Access Compliance Report

Public Rights-of-Way

Intersection ID: 11815	Main Street: N_POPLAR_ST	Cross Street: W_7TH_ST	Location: W
ADA ID: 58F1F7AF964D	Ramp Type: PerpDiag	Initial Pass/Fail: Fail	Overall Compliance: No
			Severity Score: 26.25

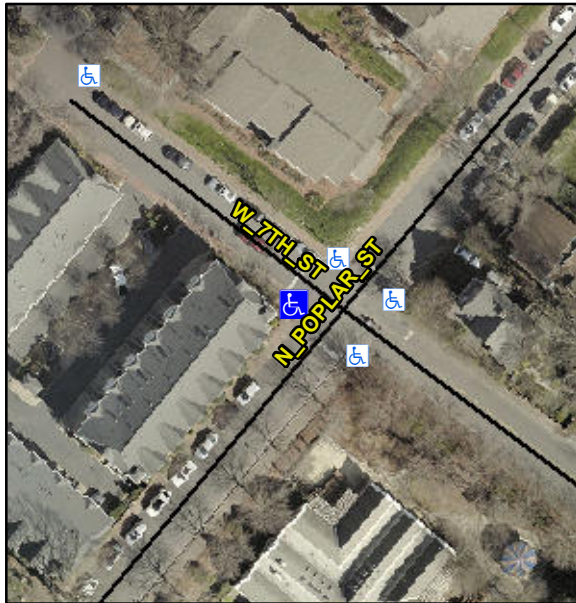
Not Found, R304.2.2, R304.5.3

Compliance	Description	Data	Compliance	Description	Data
N/A	Ramp Length (in)	39.0	No	Ramp Slope (%)	12.2
Yes	Ramp Width (in)	48.0	No	Ramp XSlope (%)	4.8
N/A	Flare Type LT	N/A	N/A	Flare Type RT	N/A
N/A	Flare Slope LT (%)	N/A	N/A	Flare Slope RT (%)	N/A
N/A	Flare Traversable LT?	N/A	N/A	Flare Traversable RT?	N/A
N/A	Landing Length (in)	N/A	N/A	DWS Provided?	N/A
N/A	Landing Width (in)	N/A	N/A	DWS Contrast?	N/A
N/A	Landing Slope (%)	N/A	N/A	DWS Length (in)	N/A
N/A	Landing X Slope (%)	N/A	N/A	DWS Full Width?	N/A
N/A	Landing Curb? (Y/N)	N/A	N/A	DWS Offset (in)	N/A
N/A	Shared Landing?	N/A			
N/A	Gutter Ponding?	N/A	N/A	Gutter Slope (%)	N/A
N/A	Gutter Lip Ht (in)	N/A	N/A	Gutter X Slope (%)	N/A
N/A	Painted X Walk1?	No	N/A	Painted X Walk2?	No
	X Walk 1 Direction	To SE		X Walk 2 Direction	To NE
N/A	X Walk 1 Width (in)	N/A	N/A	X Walk 2 Width (in)	N/A
	X Walk 1 Slope (%)	6.7		X Walk 2 Slope (%)	4.0
	X Walk 1 X Slope (%)	2.2		X Walk 2 X Slope (%)	2.9

N/A	Ramp inside XWalk1?	N/A	N/A	Ramp inside XWalk2?	N/A
	Road Slope (%)	2.0	N/A	Clear Space?	N/A
	Road X Slope (%)	5.6	N/A	Clear Space to XWalk (in)	N/A
N/A	Any Obstructions?	N/A	N/A	Storm Grate/Utility Hazard?	N/A
	Obstruction Type			Storm Grate/Utility Type	
		N/A			N/A
			Yes	Surface Condition? (G/P)	Good

Remove & Replace Curb Ramp With Two New Directional Ramps or Equivalent.
